A614 Warren Hill Gyratory

**Road Safety Audit
Stage 1 - Completion of Preliminary Design**

SA2288B
Dec 2019

Stage 1 Road Safety Audit

4. Reference Locations

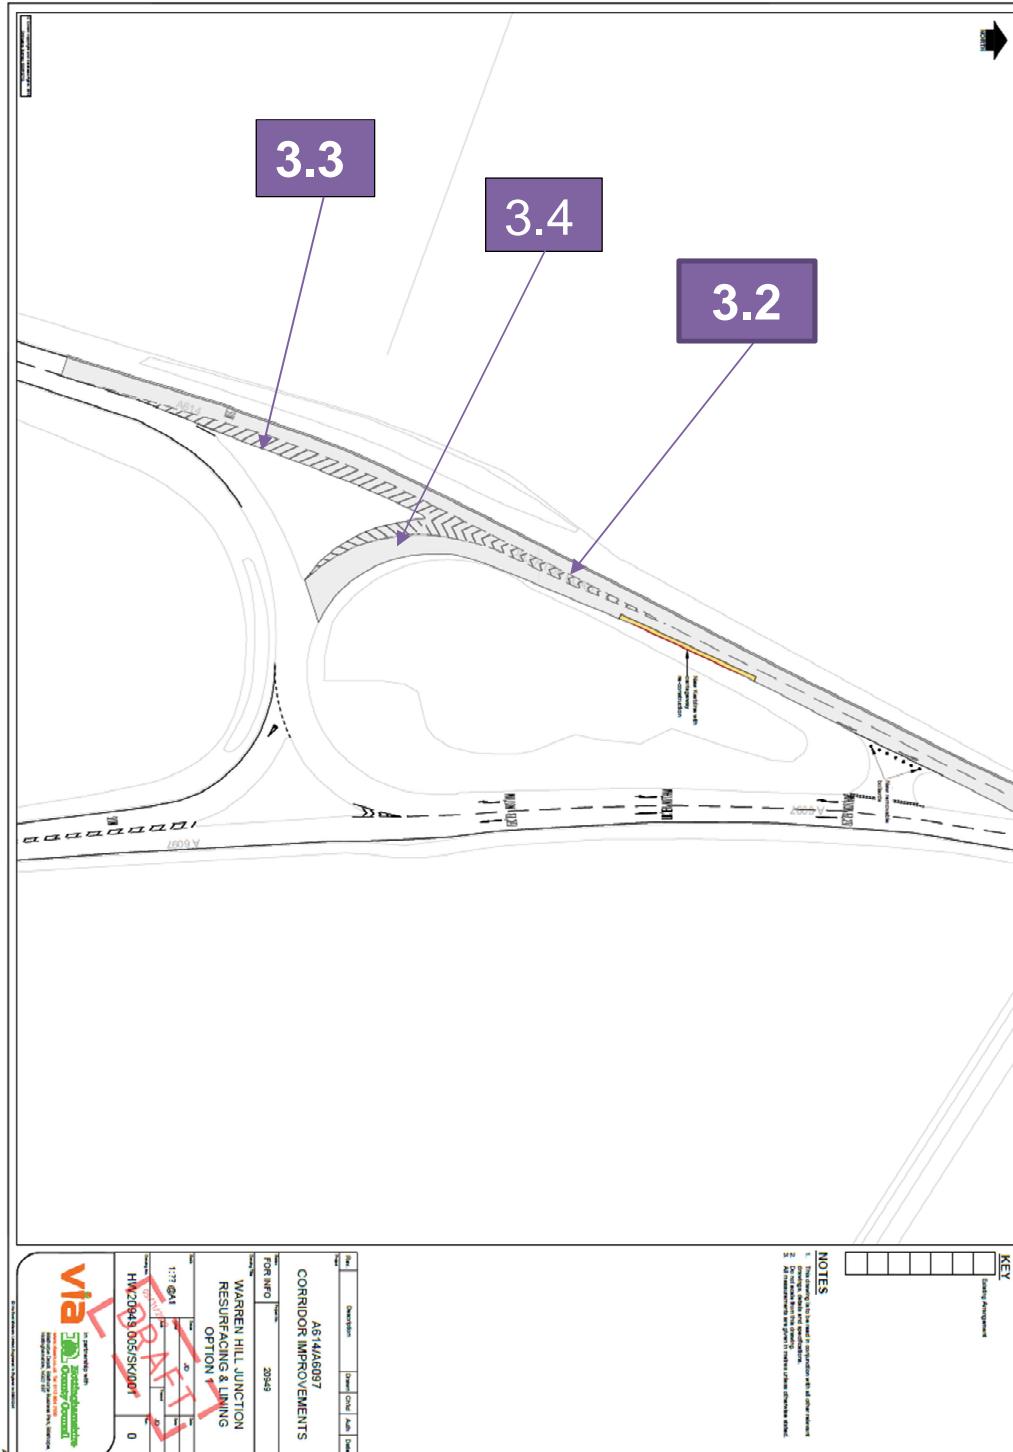
Location: A614 northbound merge.

Summary: Late-merging vehicles may collide with each other, go head-on with opposing traffic or create a shunt type accident resulting in driver/rider injury.

Now northbound drivers from the A6097 have to give way and gap seek before joining the A614 northbound stream. In this proposal the A6097 northbound stream have to merge with a faster A614 northbound stream over a relatively short distance. This is an unusual manoeuvre, as offside lane traffic is usually travelling faster and seeks to merge over a specifically designed length for the speed of road. More hesitant drivers will find this a difficult manoeuvre. Failure to merge could result in side swipe accidents, head on collisions or shunt type accidents with subsequent driver/rider injury.

Location: A614 northbound proposed hatching in offside lane.

Summary: A614 northbound drivers failing to observe the hatch markings leading to overtaking accidents/side swipe accidents and resulting in driver/rider injury.

Presently, A614 northbound drivers can travel in two lanes until the DWL system north of the gyratory. Drivers may still use the hatched lane to overtake slower moving vehicles in the nearside lane. The slight crest on the A614 may mask a vehicle joining the A614 stream at the merge as this will now be over the crest. This could result in overtaking/side swipe accidents at high speed resulting in driver/rider injury.

Location: A614/A6097 northbound gyratory radius.

Summary: A6097 northbound drivers accelerating around the gyratory radius to match merge speeds on the A614 lose control resulting in driver rider injury.

In order for northbound drivers from the A6097 to match the merge speeds on the A614, drivers may accelerate around the gyratory radius. In these proposals the radius of the bend has been tightened by the hatch markings. This could result in bend loss of control accidents and driver/rider injury.

Provide the merge length required for this speed of road and ensure all road markings are laid in a MMA material to ensure road markings are highly visible and do not suffer from early wear and become a maintenance liability. Reduce the vegetation on the gyratory so that following vehicles from the A6097 can see across the gyratory to merging vehicles ahead.

Physically reduce the A614 northbound approach to one lane with hard kerbing to prevent overtaking.

Assess the texture of the road surface on the bend, check SCRIM readings and improve surface texture if necessary.
